World Forum for Harmonization of Vehicle Regulations

Proposal for 03 series of amendments to UN Regulation No. 55 (Mechanical couplings)

Submitted by the Working Party on General Safety Provisions*

Example of an arrangement of the approval mark

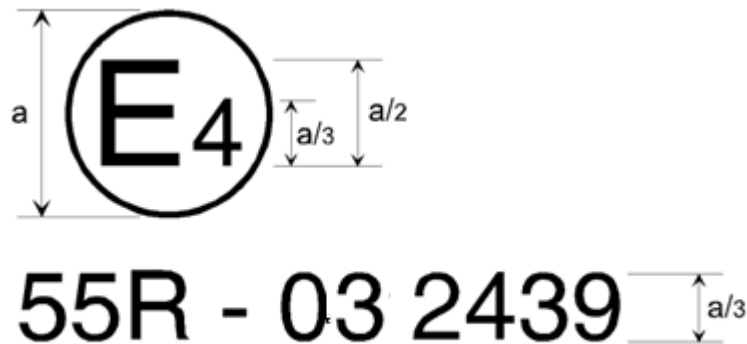
Annex 3, amend to read:

The mechanical coupling device or component or vehicle bearing the approval mark shown above is a device or component approved in the Netherlands (E 4), under approval number 2439, meeting the requirements of the 03 series of amendments to this Regulation.
